ADDENDUM NUMBER 2

**Carter Residence
260 Knollwood Drive
New Haven, Connecticut**

Project Number 1748

8th of July 2015

SCALE 1" = 10' 29 APRIL 2015
SHEET C100

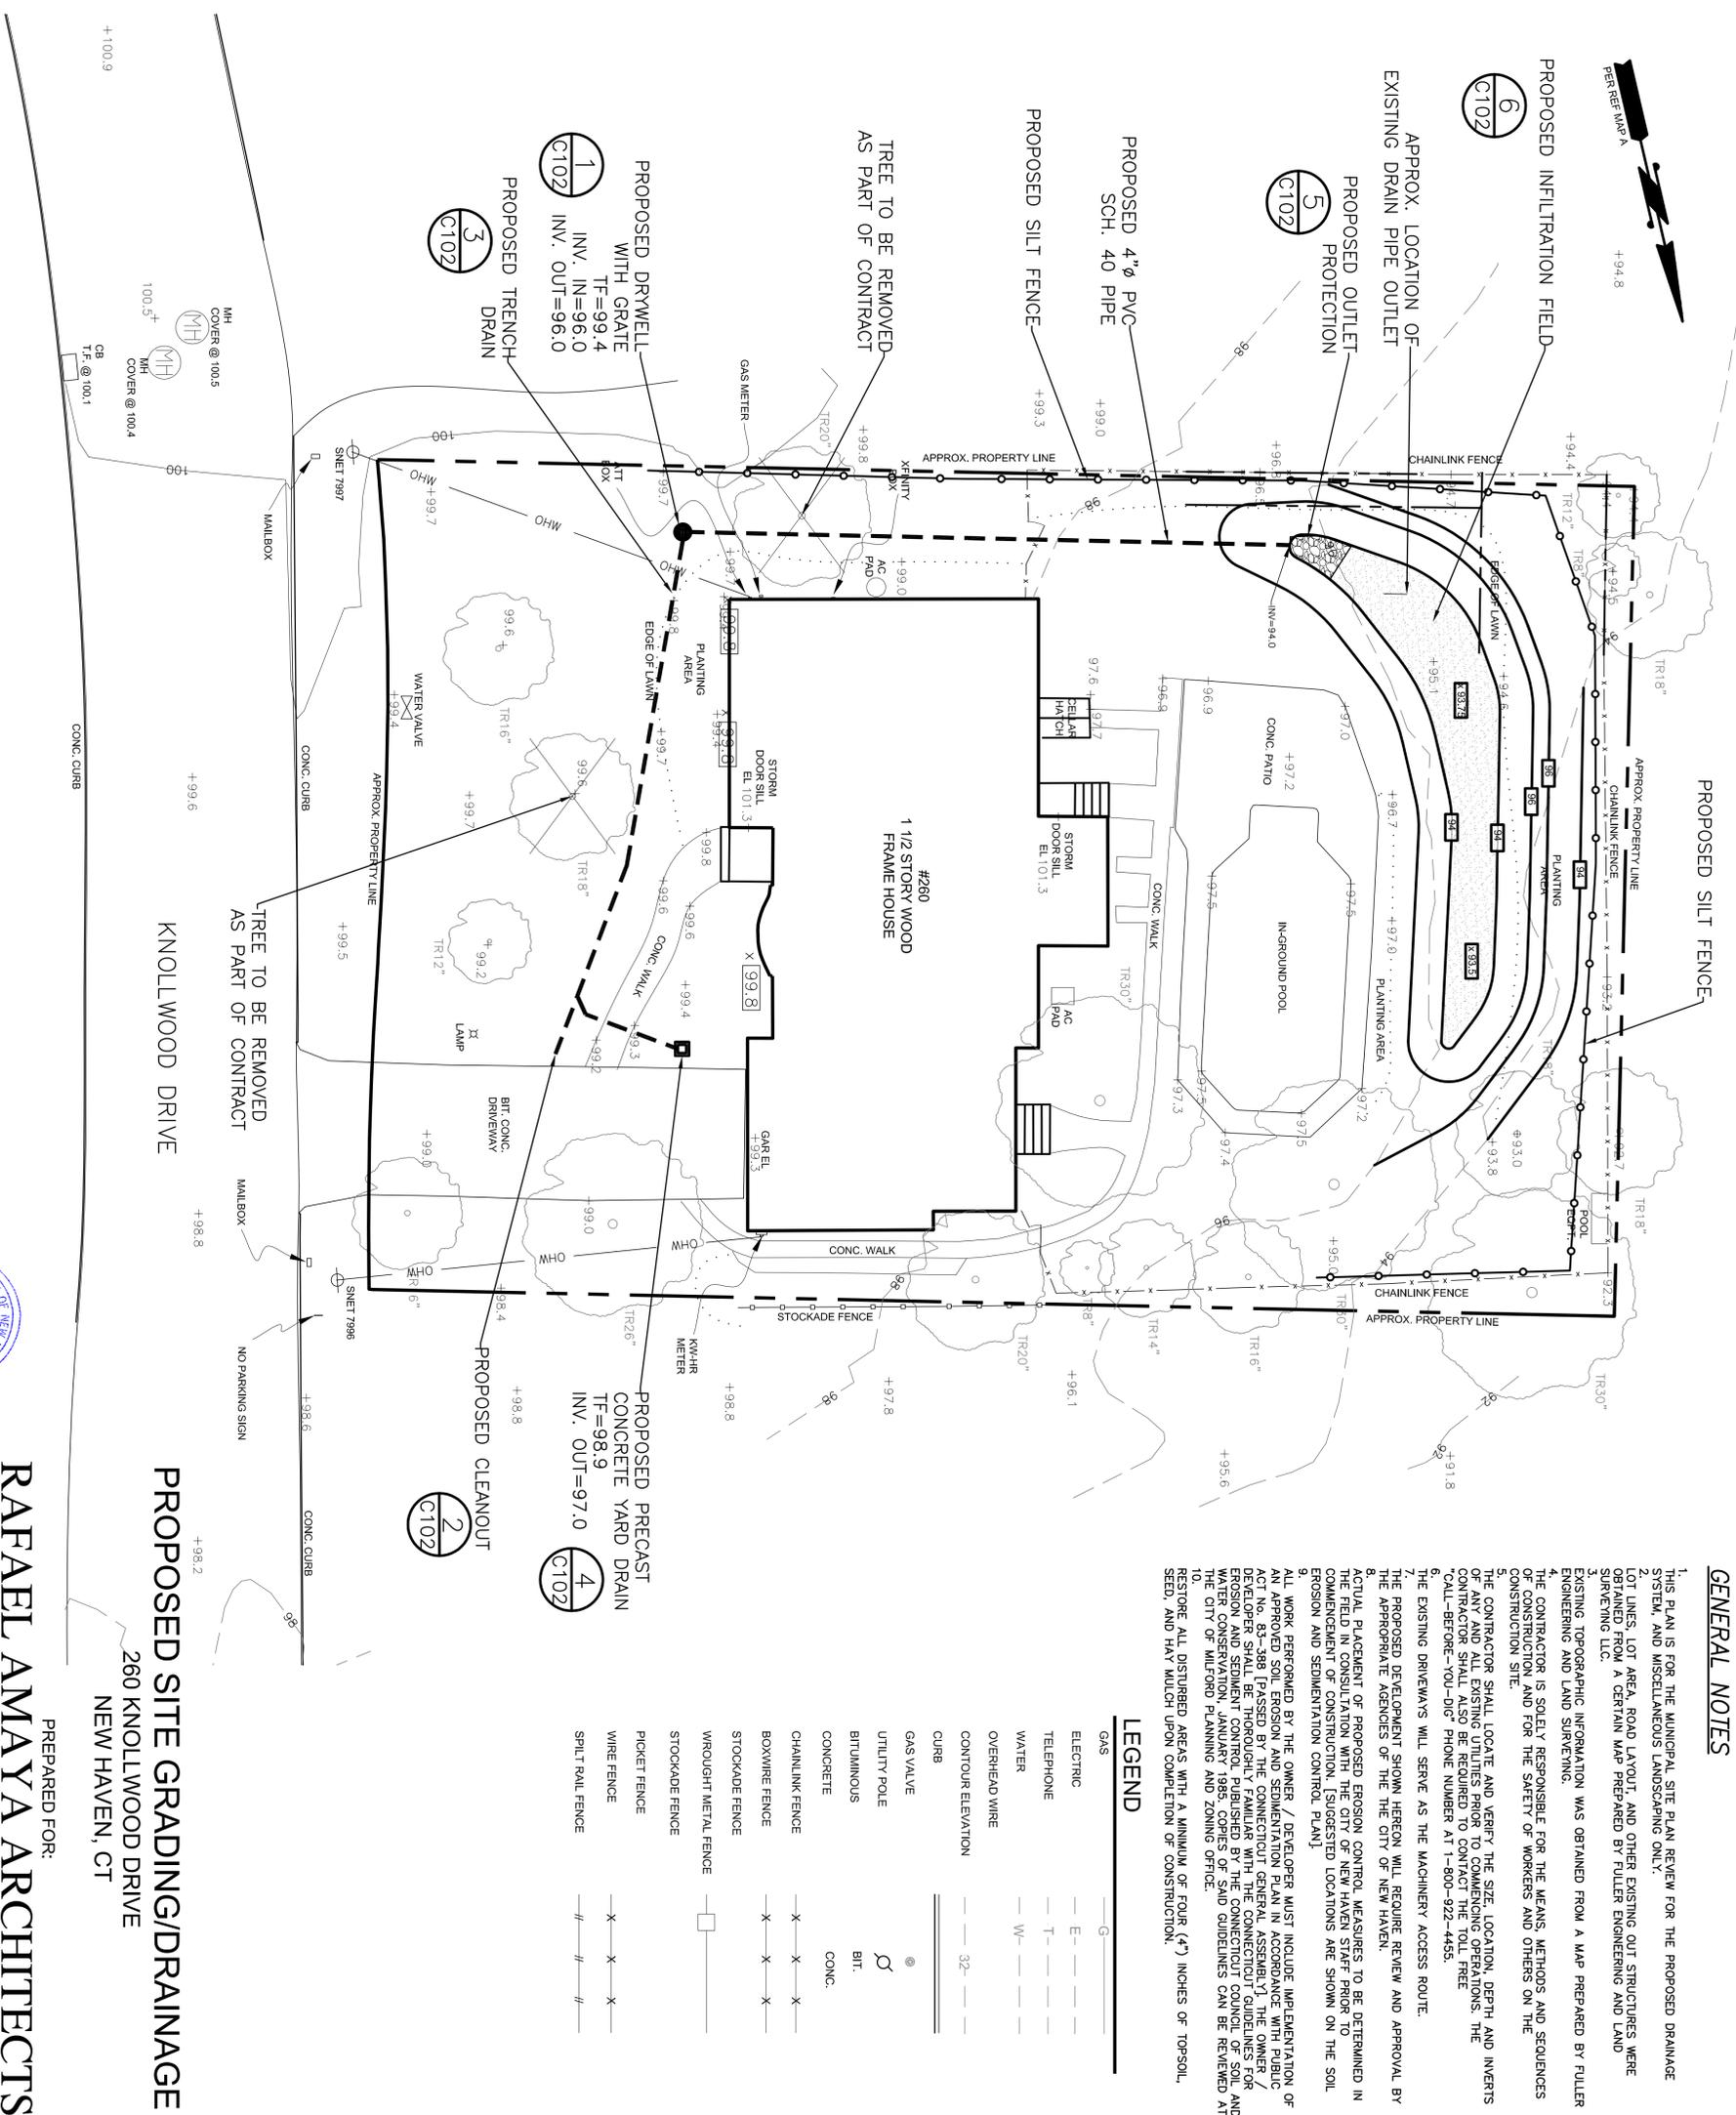
5	C100	<p>Proposed Site Grading/Drainage – Delete Drawing C100 dated the 29th of April 2015. Replace with new C100, Drawings dated the 7th of July 2015. Revised Drawing Sheet C100 is attached to this Addendum for reference.</p> <p>Note Modifications – As indicated on the Drawings, and as follows...</p> <p>Removal of two existing trees. One on the East Side and one on the South Side of the house. Removal should include stump and root base. Level area and re-seed to match adjacent conditions.</p> <p>Modifications to the retention area.</p>
6	C101	<p>Proposed Site Grading/Drainage – Delete Drawing C101 dated the 29th of April 2015. Replace with new C101, Drawings dated the 7th of July 2015. Revised Drawing Sheet C101 is attached to this Addendum for reference.</p> <p>Note Modifications – As indicated on the Drawings</p>
7	C102	<p>Proposed Site Grading/Drainage – Delete Drawing C102 dated the 29th of April 2015. Replace with new C102, Drawings dated the 7th of July 2015. Revised Drawing Sheet C102 is attached to this Addendum for reference.</p> <p>Note Modifications – As indicated on the Drawings, and as follows...</p> <p>Added Detail – Typical Sectional Detail of Drain Swale.</p> <p>Added Notes for Swale and Bio-Retention Soil Mix.</p>
